Re: Condition of The Gateway Garage

RE: Gateway Garage, Portland, Maine

RE: Gateway Garage, Portland, ME

March 23, 2011

NETTING DETAIL

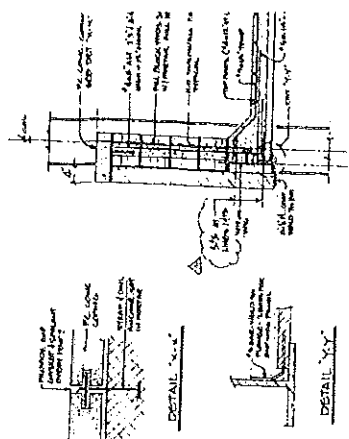
We spent a significant amount of our day looking at the façade of this structure which consist of a brick veneer and CMU back-up and capped by precast concrete cap. The wall is supported by a steel beam embedded in the slab and a steel plate that is attached to the bottom flange of the beam. This plate cantilevers out to support the brick façade and was the item that fell from the structure last week. Based on our review we do have some concerns about the long term stability of the façade system. During our review we removed loose pieces of mortar, brick, precast and CMU. We also noted several areas where we were concerned about the connection of the plate to the steel beam. Based on our limited review of the structure it would be impossible for us to predict or speculate on whether or not more plates are going to fail in the near future. We do believe that it would be prudent to install some temporary protection, especially at the areas directly above walking and driving areas, as soon as possible. This will offer protection to pedestrians and parkers as we work to develop repair details and continue our review of the façade. Based on our discussions with the Owners we will work with the contractor to install netting at the areas of highest risk as a temporary measure until permanent repairs can be installed.
